May 3, 2006 BZA

REQUEST ANALYSIS
AND
RECOMMENDATION

06AN0260

REQUEST: A two (2) foot Variance to the four (4) foot fence height limitation in the corner side yard in a Residential (R-9) District.

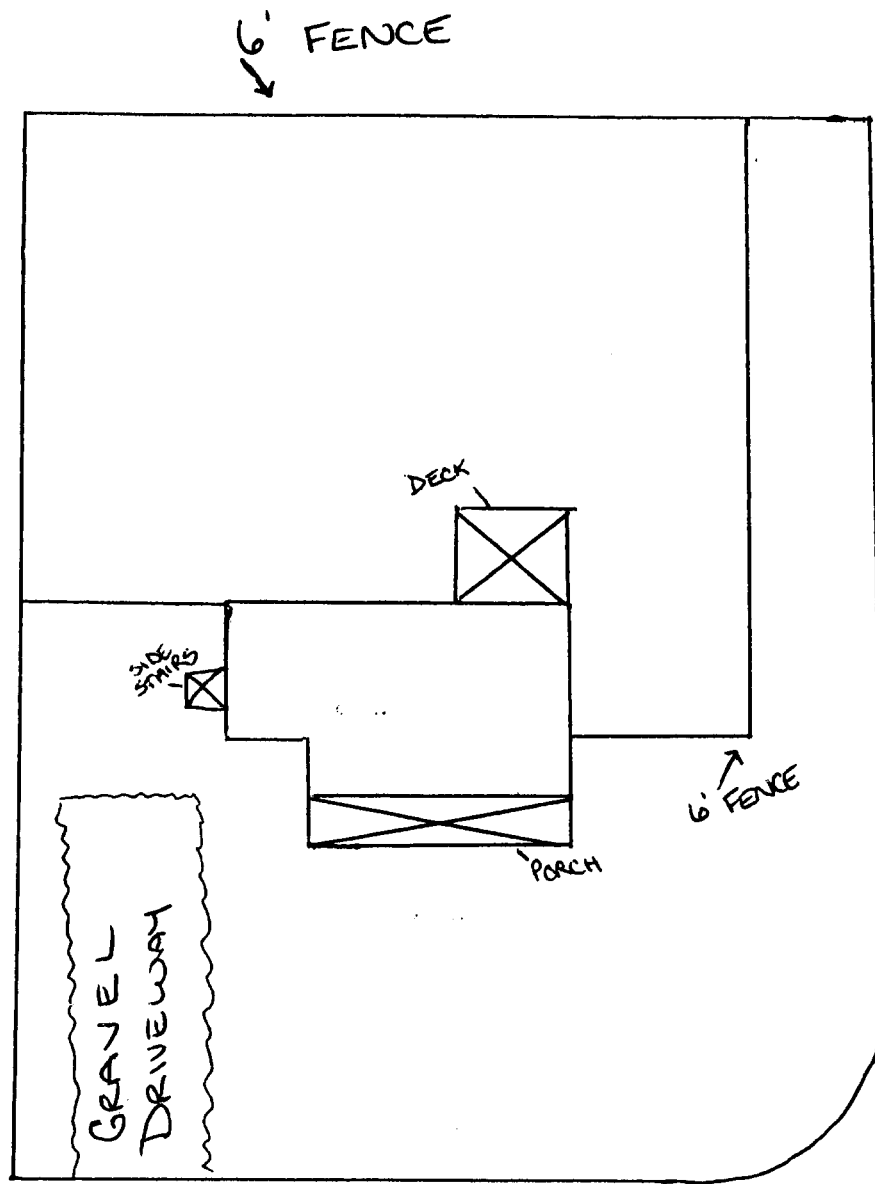
Staff visited the property and observed a six (6) foot wooden privacy fence in the corner side yard at 10751 Timberun Road in the Great Oaks Subdivision. There are bushes and trees in front of the privacy fence in the front yard. Staff also observed three (3) other corner lots at the same intersection with approximately three (3) foot picket fences in the corner side yards.

Although the fence does not create a site distance issue for traffic, it does unreasonably restrict the free flow of light and air. It creates a closed-in appearance to the neighborhood. Appropriate subdivision design dictates open flow along the roads. A two (2) foot reduction in the fence height would accomplish that free flow and open up the road corridor.

Staff believes that there are several alternatives that exist that would eliminate the need for this Variance. If the height of the fence were reduced to four (4) feet, it would comply with the Zoning Ordinance. Also, the six (6) foot fence could be located totally in the rear yard. In order to accomplish this, the fence could be moved to the right rear corner of the dwelling and extend on a direct perpendicular line to the rear property line.

This Variance shall be for the existing fence only and no other additional fence shall be added.
